MODEL: PL-2, 4, 5, 6, 7, 120, 220, 230, 320, 330, 420, 430, 620, 720, 730, 930

SUBJECT: POOR CONTACT POINTS IN THE SPEED SELECTOR SWITCH

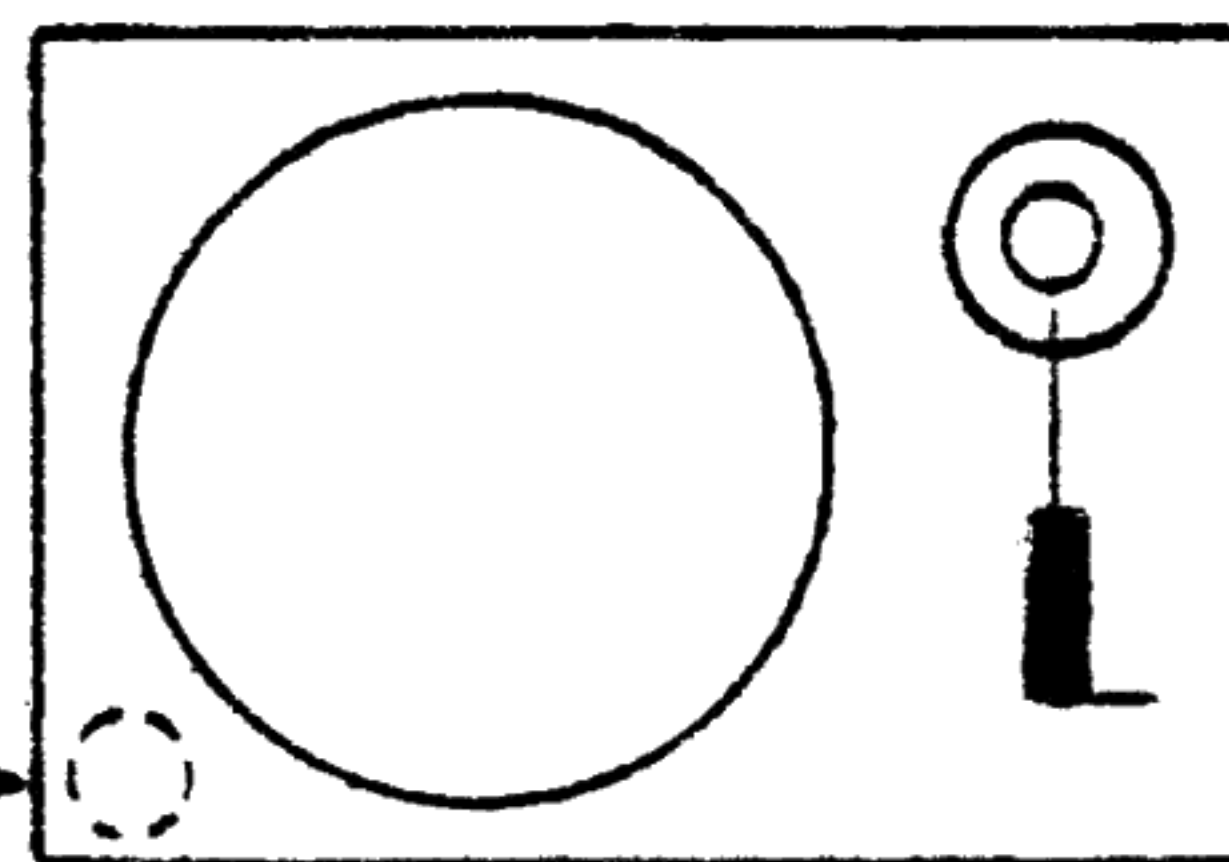
CAUSE: UNDER CERTAIN ENVIRONMENTAL CONDITIONS, A 'BLOOMING' OF THE RUBBER DAMPER CUSHION (PART OF THE FOOT) WILL OCCUR WHICH PRODUCES A SMALL AMOUNT OF SULFIDE GAS. THE SULFUR IN THIS GAS WILL ACT UPON THE SILVER ON THE CONTACT POINT SURFACE CAUSING A CORROSION WITHIN THE SPEED SELECTOR SWITCH. THIS CORROSION OF THE CONTACTS IN THE SWITCH WILL CAUSE THE UNSTABLE MOTOR SPEED.

The distance between the rubber damper cushion and the Speed Selector Switch has influenced the problem. If it is more than 40mm, the problem will not occur. However, the switch is close enough to one of the four rubber cushions and can be affected by this condition.

This Rubber Cushion is affecting the Switch

Countermeasure: The material of the Rubber Cushion has been changed.

Material: Butyl Rubber

Silicone Rubber

Only the Rubber Damper Cushion nearest to the Speed Selector Switch should be changed. To distinguish the new part, the color of the rubber is changed from BLACK (Butyl) to GREY (Silicone).

Note: When servicing a unit with this problem, please replace the switch and the rubber cushion at the same time. Also, note that it is only necessary to replace the rubber cushion that is nearest to the Speed Selector Switch. DO NOT replace all four rubber cushions in the unit.
